MAGNET HOLDER - OD 82 mm

Dimensioned reference | Dimensions in mm | Print at 100% / Actual size

GEOMETRY AND REVISION - 19 OCTOBER 2026

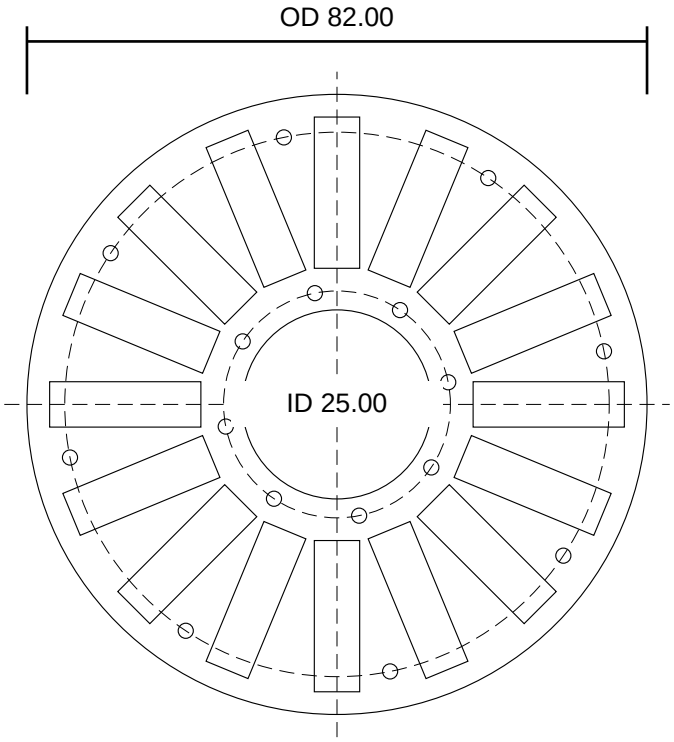
Revision: OD 80 to 82; openings 19.75 x 5.75 to 20.00 x 6.00.

Test-cut one opening and confirm a sliding fit before cutting the full holder.

Diameter 2.00 retains the existing template; confirm final fastener clearance.

Confirm clearance to PCB nuts, washers and rotor runout in the assembled motor.

Outer diameter 82.00; central opening diameter 25.00.

16 bolt-hole circles, diameter 2.00: 8 on PCD 72.00 and 8 on PCD 30.00.

Each ring: 45 degrees apart; first centre 11.25 degrees counterclockwise from right axis.

16 openings: 20.00 radial x 6.00 tangential; centres at radius 28.00.

Openings: 22.5 degrees apart; first opening points right.
